6. 8 Bow Street (add doors and windows)

# Application for Approval - Administrative Historic District Commission

# 8 BOW STREET

## Historic District Commission - Administrative Approval - July 2018, Portsmouth, New Hampshire

ITEM #1: VIEW OF ALLEY AND ACCESS DOOR

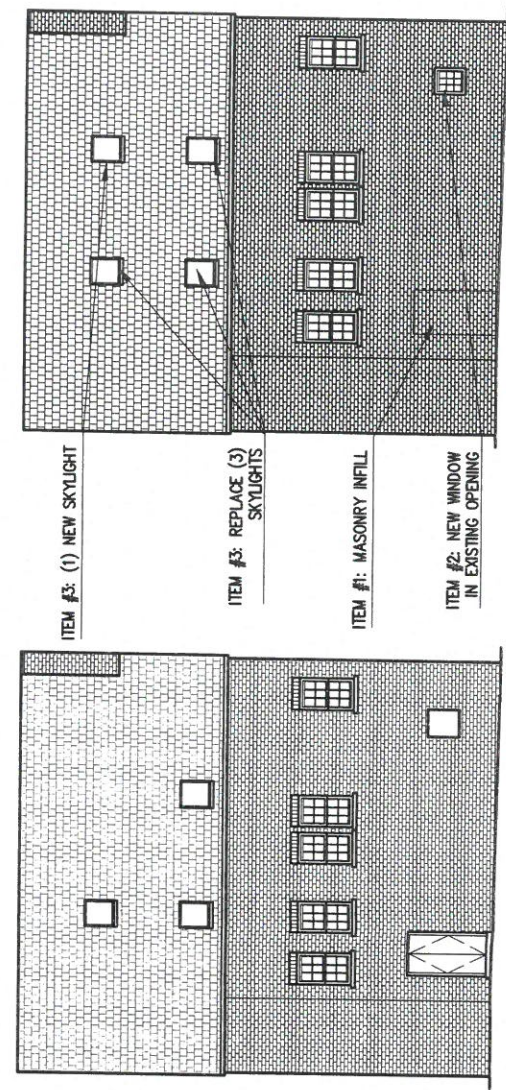
To permit the following: Request the following revisions to previously approved project  
① Masonry infill unused door at back alley ② Replace boarded up window (at alley) w/  
fixed Pella window to match all other windows in building ③ Replace (3) skylights &  
add (1) skylight at alley ④ Add window at Penhallow Bow St elevation - third floor

1. Masonry infill of unused alley access door opening.
2. Replace plywood infill in existing window opening with Pella Architectural Series Reserve fixed window to match make/manufacturer of all other new windows in building.
3. Replace (3) skylights and add (1) skylight at rear/alley side of building.
4. Install (1) new window at third floor. Size to match adjacent third floor windows. Window to be Pella Architect Series Reserve to match all other windows in building.

ITEMS #1 - #3

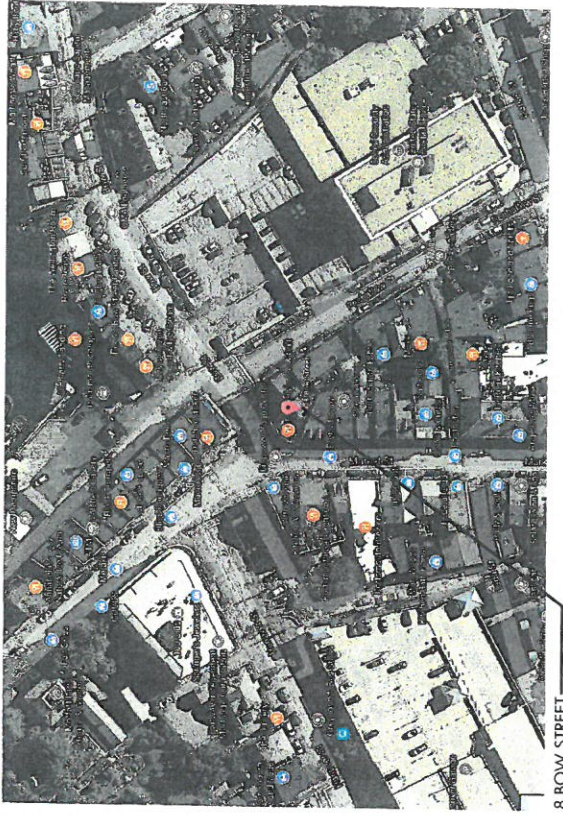
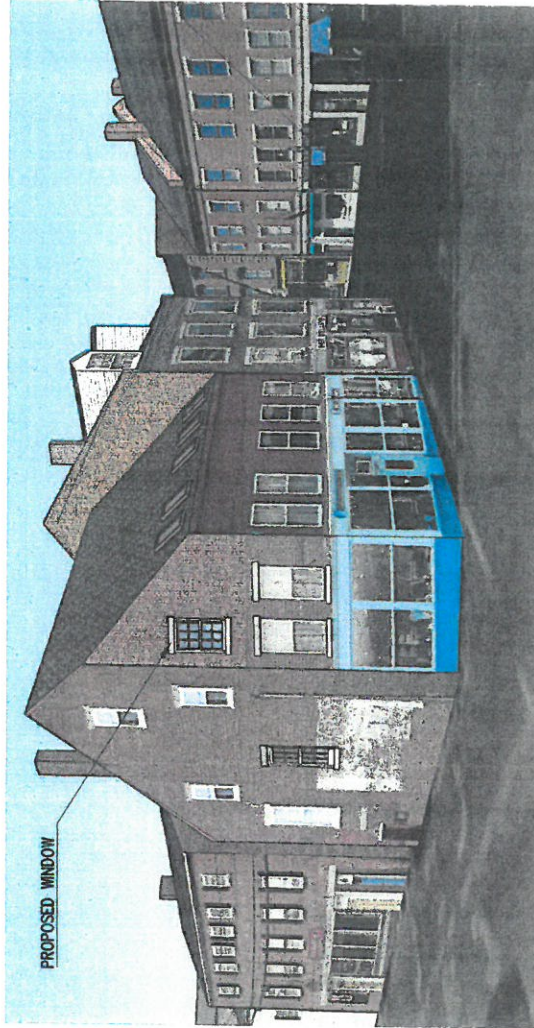
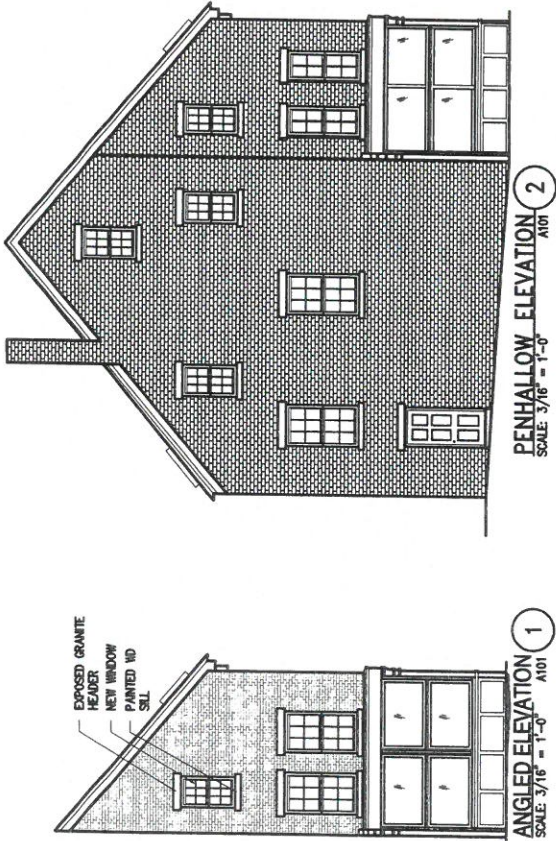
ITEM #3: REPLACE (3) SKYLIGHTS AND ADD (1) SKYLIGHT AT REAR/ALLEY SIDE OF BUILDING - TO MATCH ALL OTHER APPROVED SKYLIGHTS IN BUILDING

ITEM #2: PELLA ARCHITECT SERIES RESERVE - FIXED WINDOW - TO MATCH MAKE/MANUFACTURER OF ALL OTHER APPROVED WINDOWS IN BUILDING

EAST ELEVATION

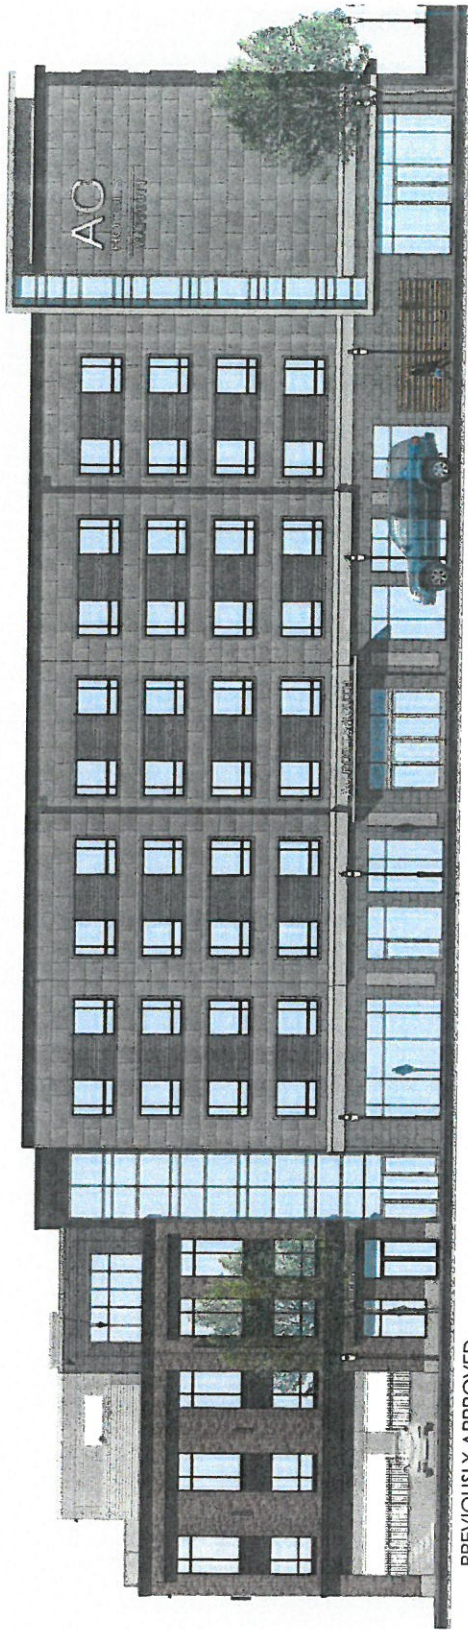
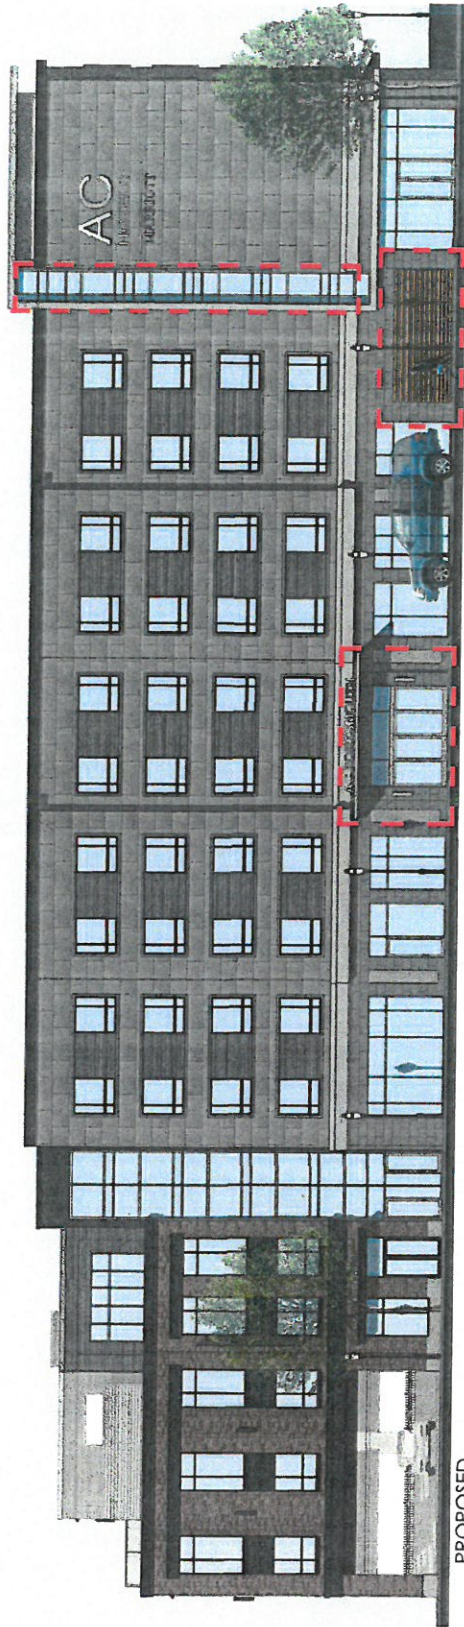
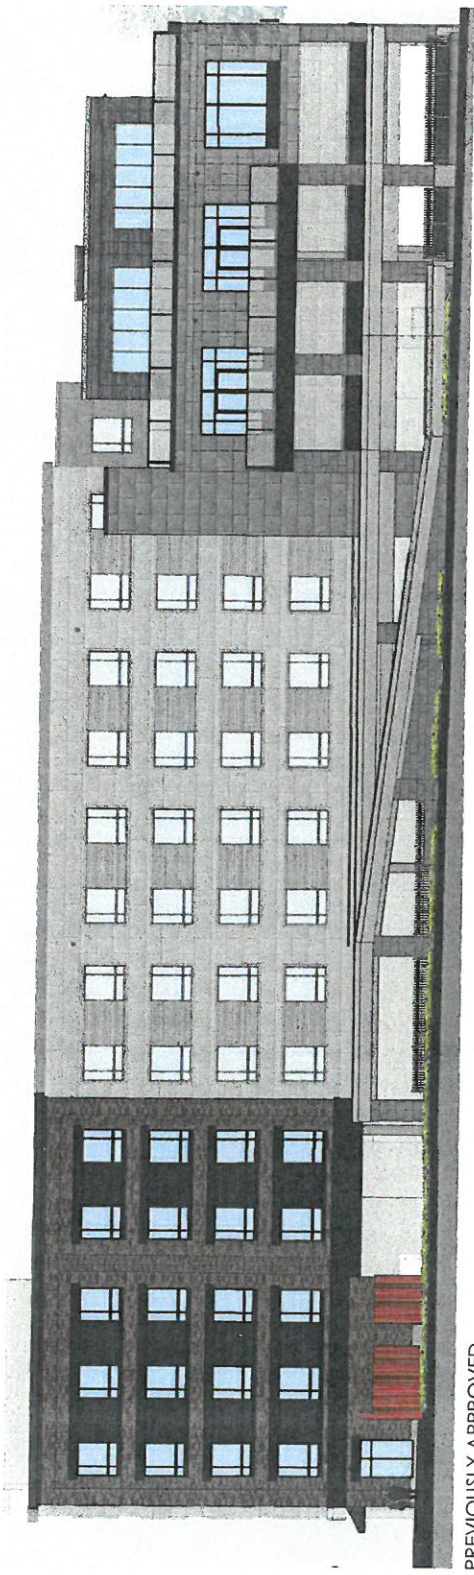
1. LED accent lights added to structure. **Please note:** accent lighting is treated as signage and will require a sign permit in addition to HDC approval.

(Response) See attached revised exterior elevations for exterior lighting locations. HDC application for administrative approval will be submitted along with colored elevations, night rendering and other required documentation.

WEST ELEVATION

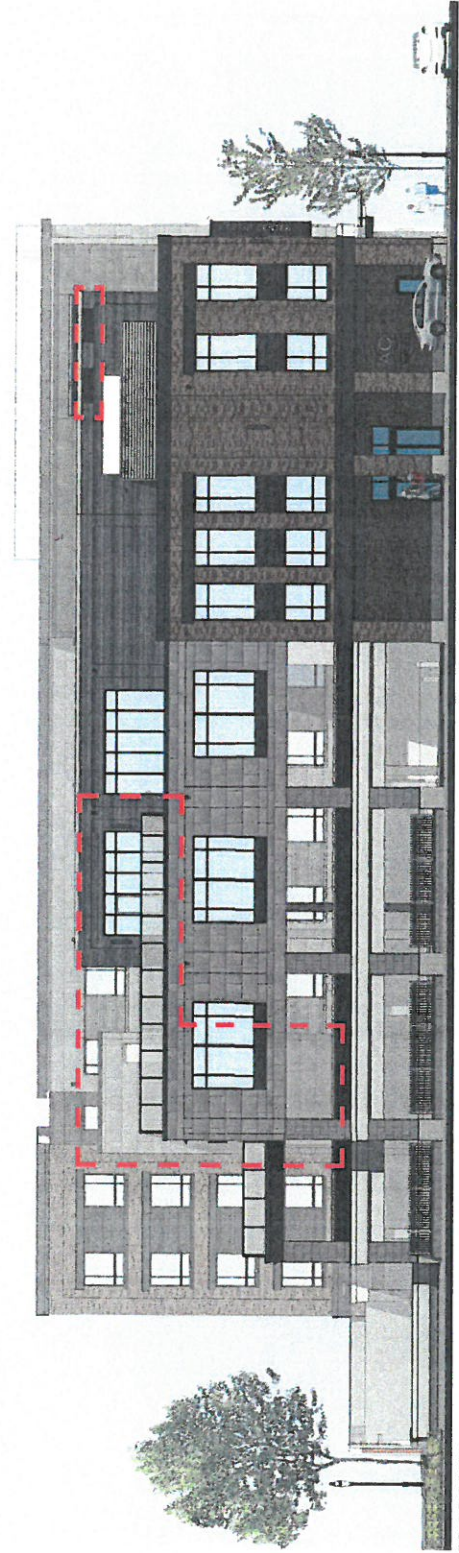
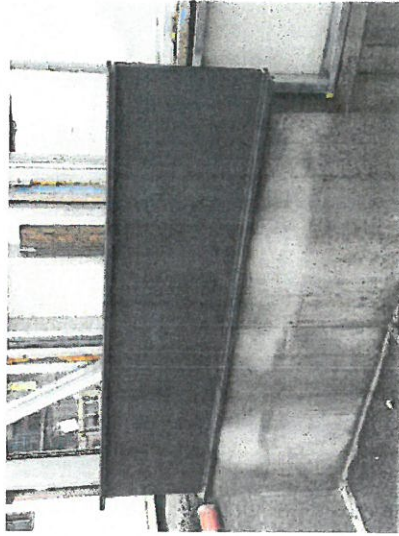
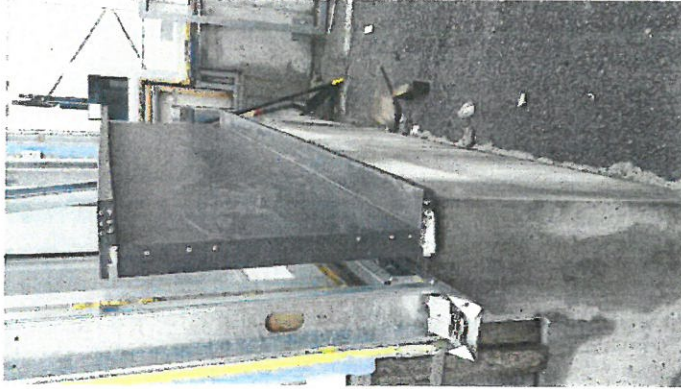
2. 2x louvers added.

(Response) The HDC approved the revised location in plan view on 3/7/18. See attached updated West Elevation, sheet 2.1, along with an HDC application for administrative approval to show the correct location in elevation.

(Response) See attached updated West Elevation, sheet 2.1, along with an HDC application for administrative approval to show added required elevator venting louvers.
